Cyprus Plateau Mining Corporation
P.O. Drawer PMC
Price, Utah 84501
(801) 637-2875

RE: MEETING SEPTEMBER 3, 1993

Thank you for the opportunity to meet last Friday regarding the Castle Valley Ridge permit hydrology issues. This letter is to confirm our understanding of the outcome of the meeting.

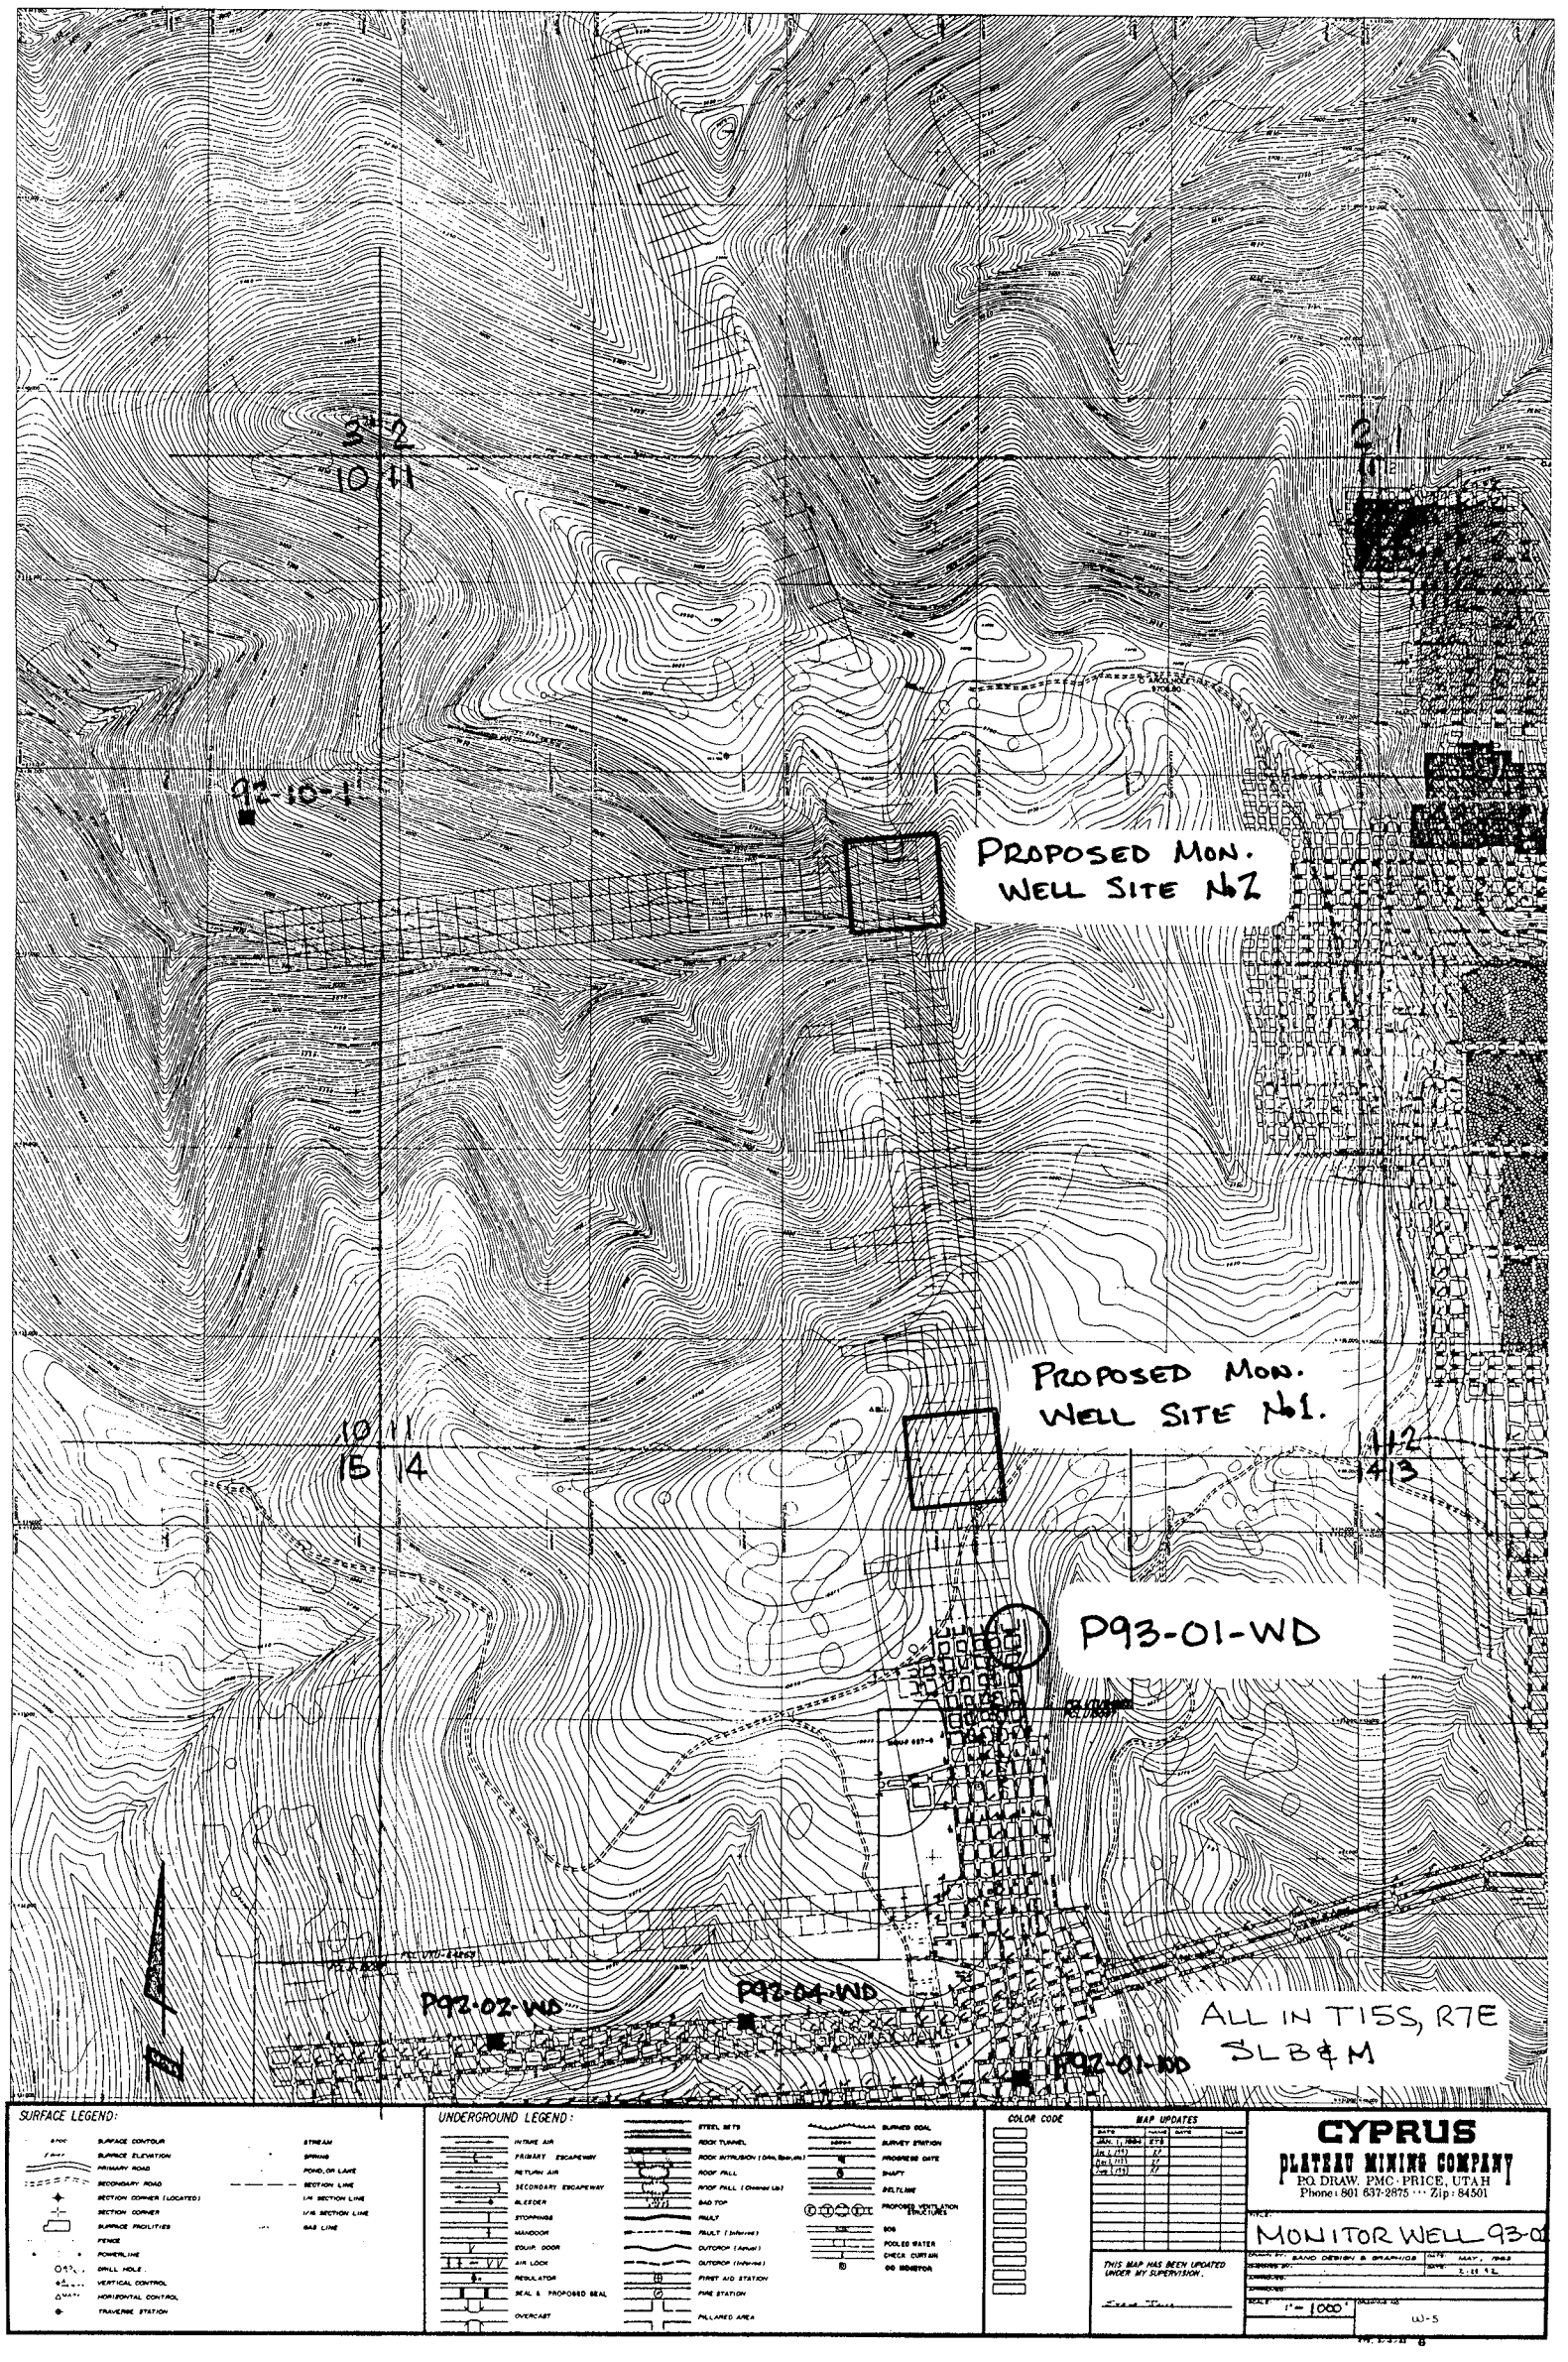
The main item of agreement was on monitoring the ground water level in the new lease UTU-64263. We agreed to drill and install a monitoring well at the location shown on the attached map labeled P93-01-WD. This well will take the place of the previously proposed well located approximately 800 feet to the north labeled Proposed Mon. Well No. 1 on the attached map.

Well P93-01-WD will be installed to help determine the ground water level in Lease UTU-64263. A comparison with the other wells labeled P92-01-WD, P92-02-WD, P92-04-WD and 92-10-1 as shown on the attached map will be made. If the water level confirms that the ground water level is below the Wattis Coal Seam and is in general agreement with the water level in the other monitoring wells mentioned, the Division will reconsider the adequacy of baseline data for Lease UTU-64263. We believe we can install the well and obtain the water level by mid to late October, and would petition the Division to expedite the reconsideration.

Additionally, it was agreed that well P93-01-WD does not need to be drilled through the Star Point Sandstone and have each unit of sandstone tested separately. The next well to the north (No. 2) may be used to test the three units of the Star Point Sandstone. A third monitoring well north of well site No. 2 was also discussed as a possibility in the future.

Tom Monson: Are you comfortable? Please see me. Thanx
LDB 9/10/93
